VILLAGE OF GERMANTOWN
N112 W17001 MEQUON ROAD, GERMANTOWN, WI 53022

MEETING:	PLAN COMMISSION
DATE AND TIME:	<u>MONDAY, APRIL 25, 2016 6:30 p.m.</u>
LOCATION:	Germantown Village Hall Board Room

SITE PLAN REVIEW

Village Planner Report Germantown, Wisconsin

OPTION "B"

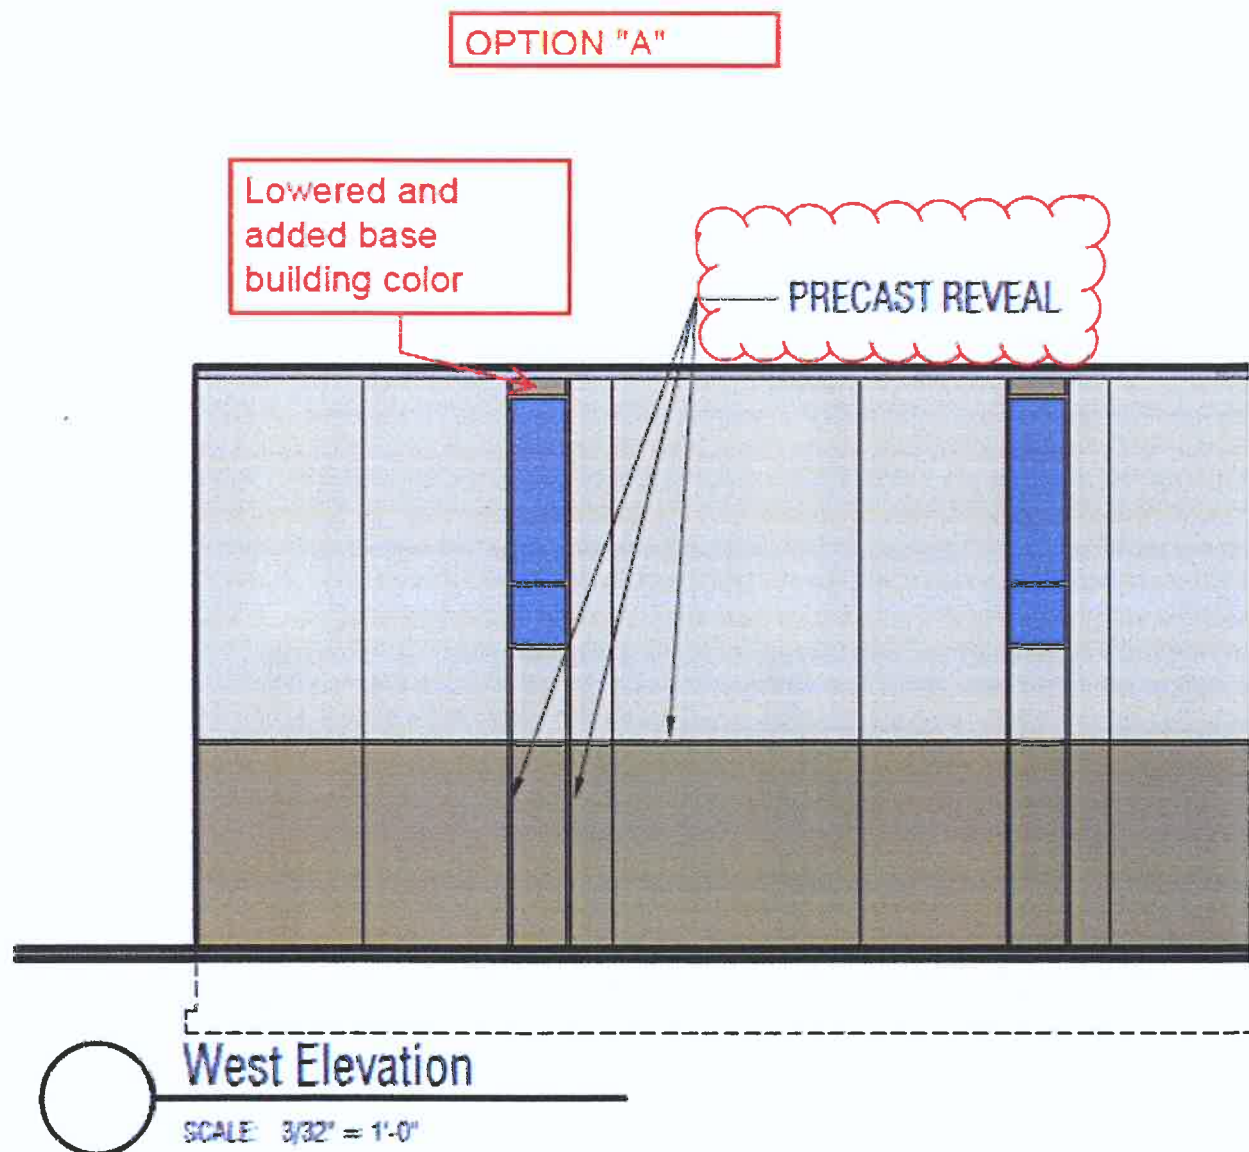
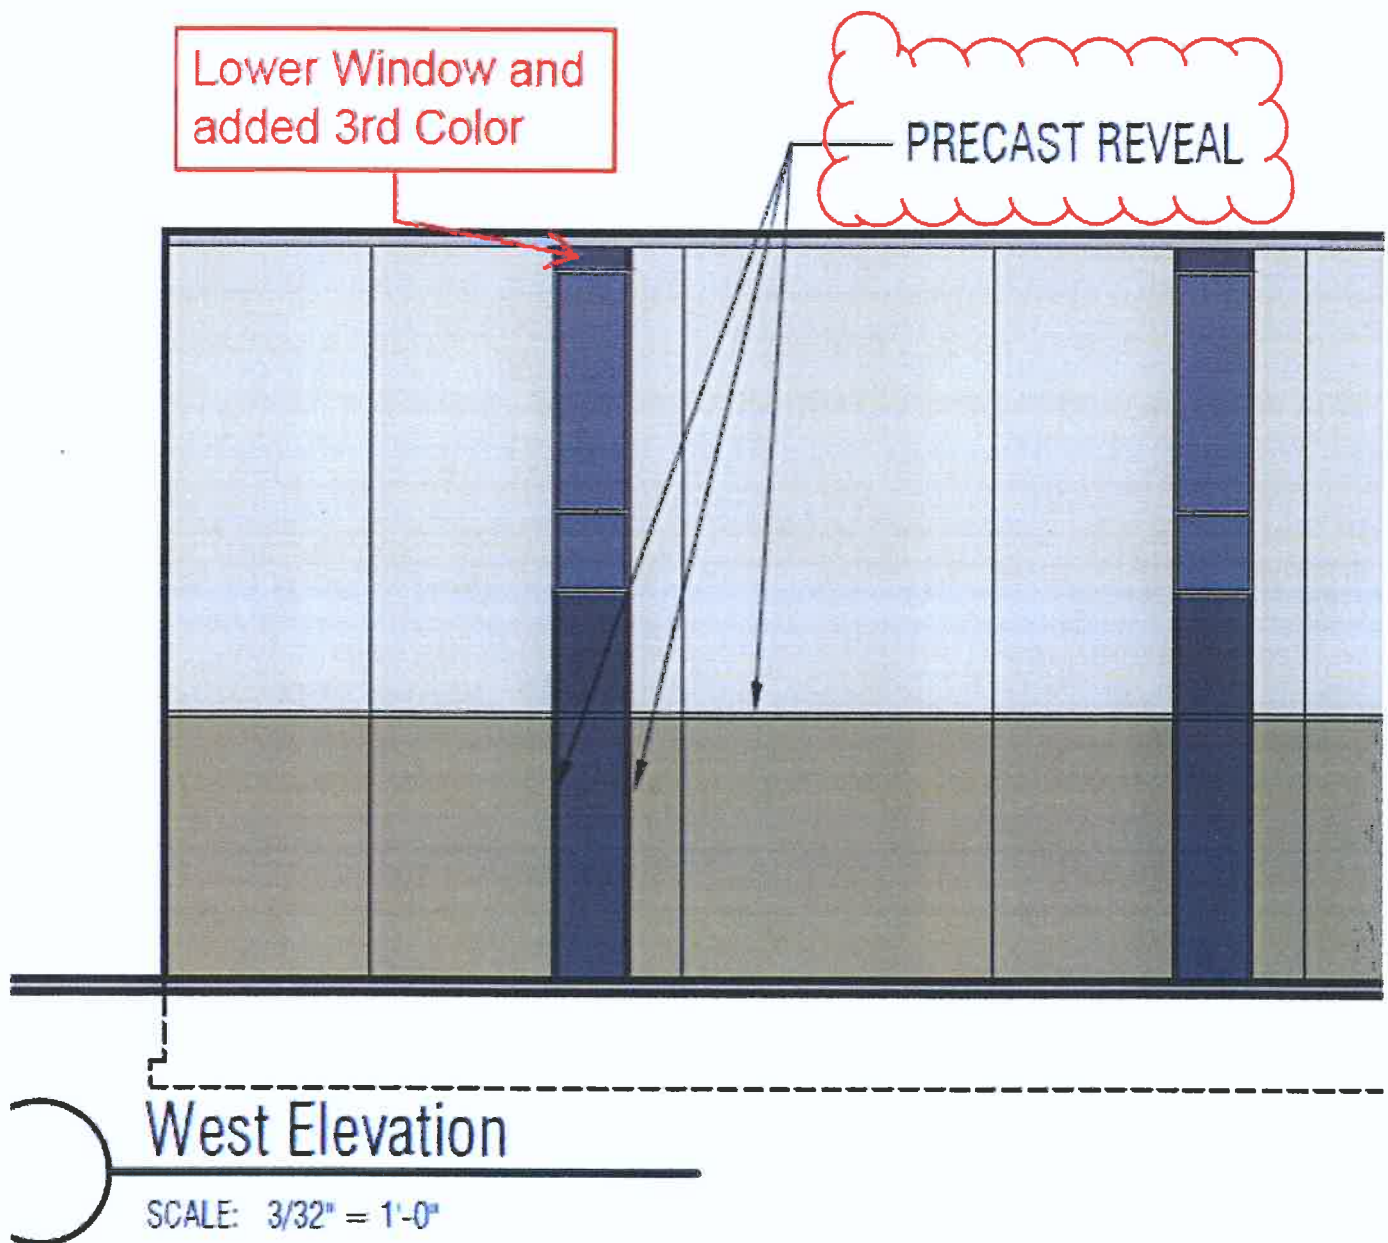
Revised building elevations have been provided by the Applicant (see enclosed elevations):

- Option "A" (the owner’s preferred option) is the same smooth concrete wall panels with additional vertical reveals below the windows. Also, the windows have been lowered to allow additional color on the building above the windows; and
- Option “B” includes the same additional reveals and lowered windows as Option "A" except that a third color has been added to the wall panels under the vertical windows. This color would be either a light grey to match the clear anodized window frames, or, a color that is in-between the two colors already proposed for the building.

Option "A" - Is really what they clients wants to do to help satisfy the PC Commission. What we have done as described in my email yesterday, is provided additional vertical reveals below the windows (Full height) to provide the look of pilasters and we have lowered the windows to allow us to add the lower color on the building to above the windows.

Option "B" - Same as Option "A" except we have introduced and third color to the area of the vertical windows. This color would be either a light grey to try and match the clear anodized frames or a color the between the two that's already on the building. Option "B" is not one the owner prefers, but if it satisfies the Village, then he will live with it.

A4.0

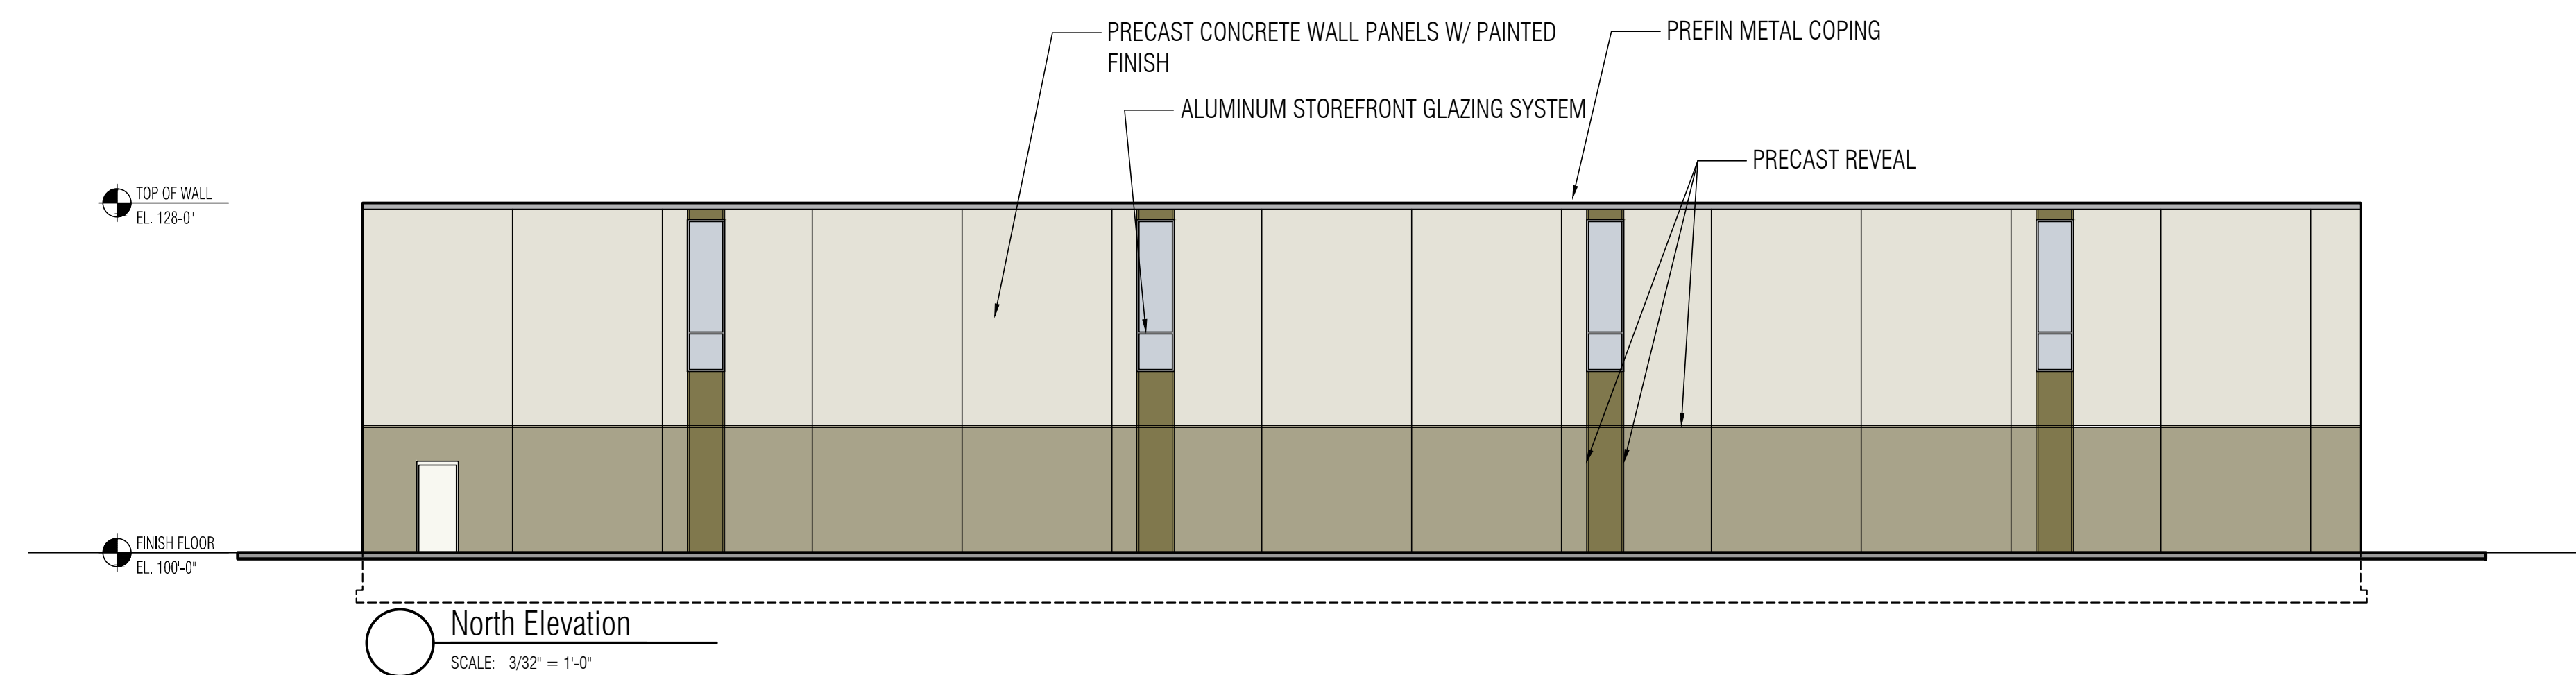
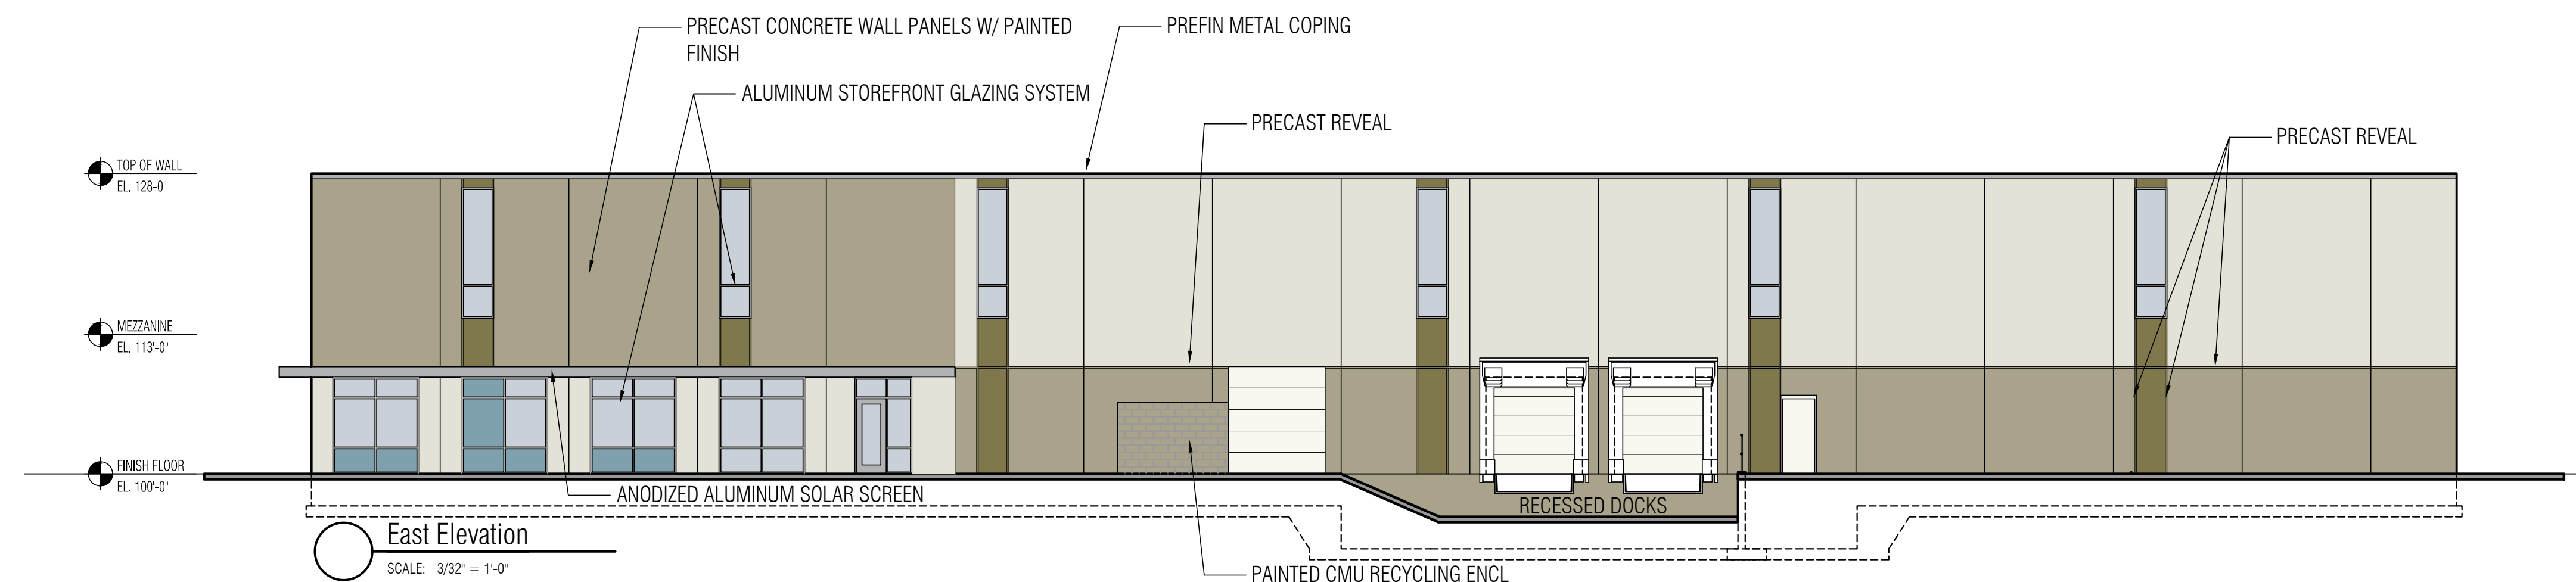
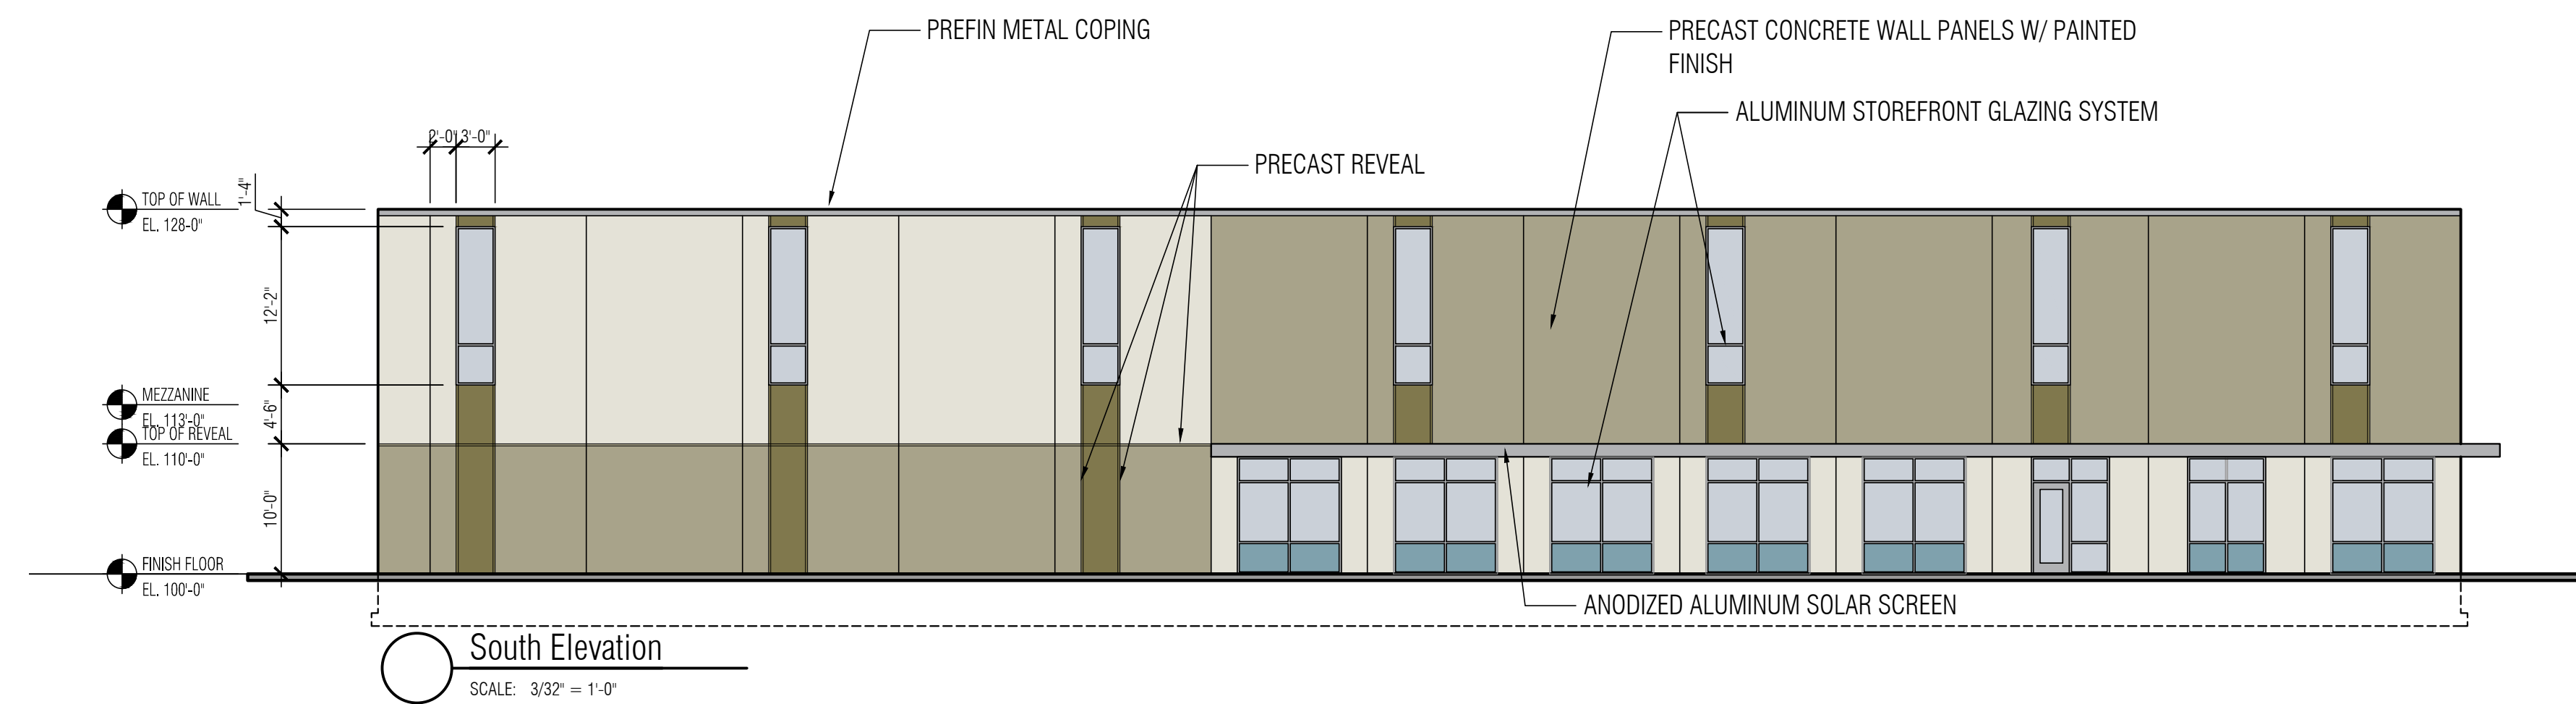
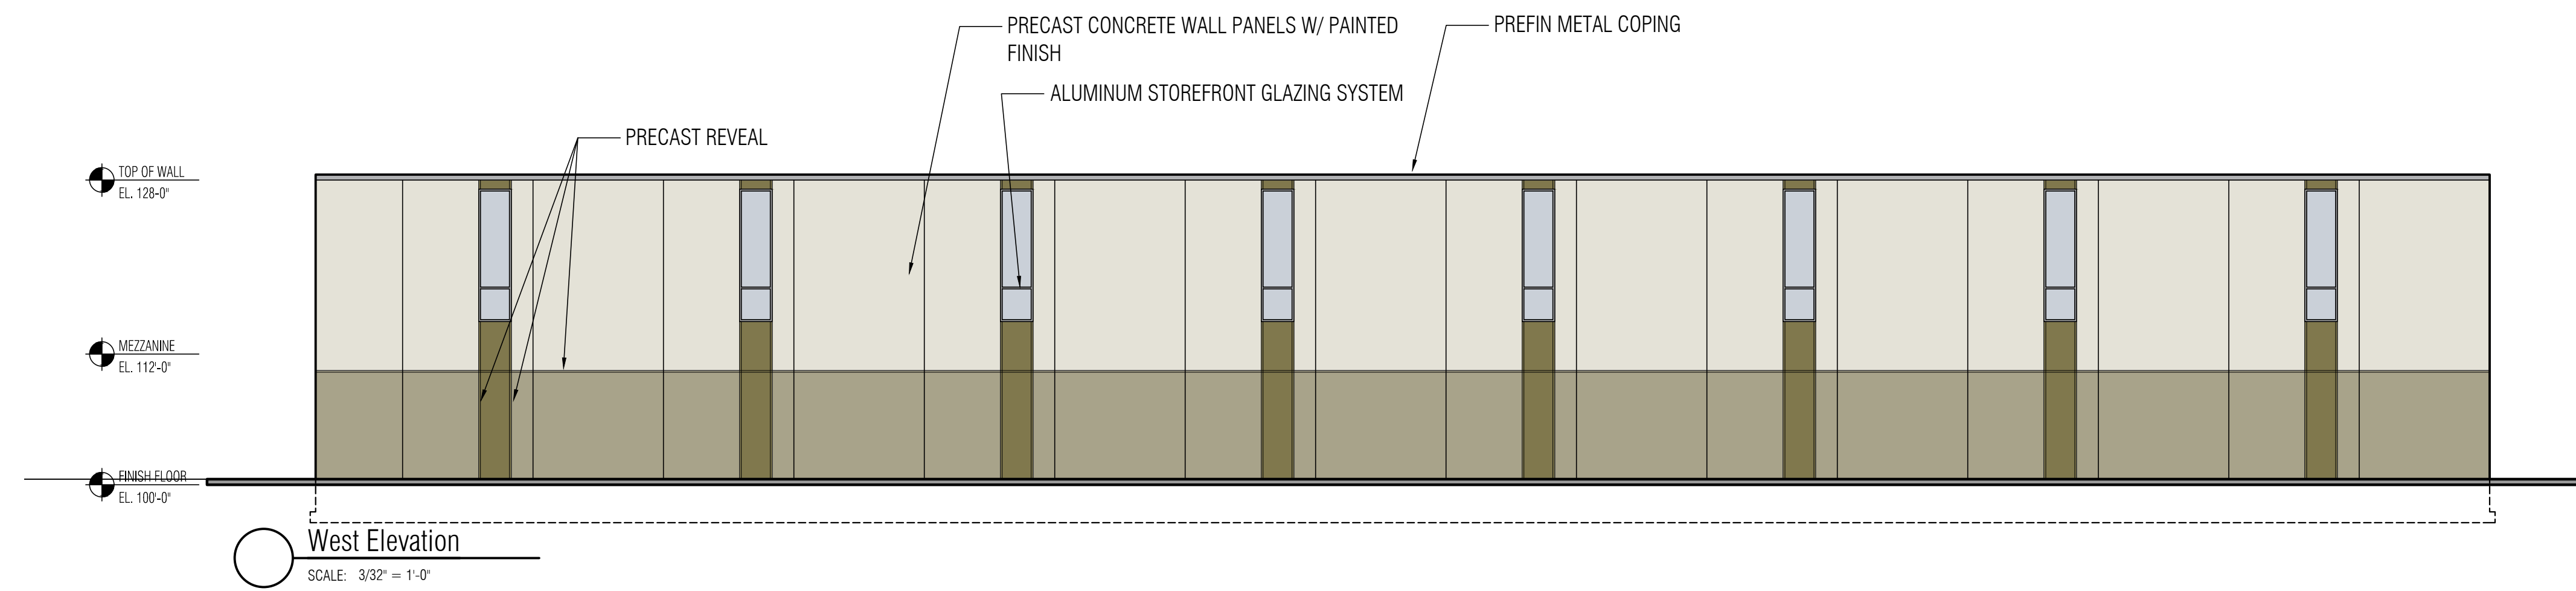
While the proposed landscaping plan does include significant landscaping that more than meets the Business Park covenants and staff concerns, the building architecture and exterior materials do not. Some type of architectural devices, e.g. pilaster, more pronounced reveals and/or articulation, material changes, etc., or other architectural features and/or enhancements should be added to the building, specifically to the south and west elevations (that also wrap the northwest corner of the north expansion wall). Also, the wall panels proposed are comprised of smooth concrete painted two different colors. While the Business Park covenants allow tilt-up concrete wall panels, the covenants discourage the use of smooth masonry block as a primary material. Staff is not sure what the difference truly is between smooth concrete block and smooth concrete wall panels, but the appearance is likely not any different. Given the above concerns, if wall panels are acceptable for this building, some sort of architectural finish in addition to color should be required.

8. To comply with the Business Park covenants and restrictions, additional architectural devices, e.g. pilaster, more pronounced reveals, wall panel articulation, material changes or other architectural features or enhancements shall be added to the south and west elevations that also wrap the northwest corner of the north expansion wall. The proposed smooth-finish wall panels shall include an additional architectural finish that is not limited to just different color. A revised elevation/architectural plan and rendering showing these changes shall be prepared and submitted to the Plan Commission for review/approval prior to issuance of a building permit.
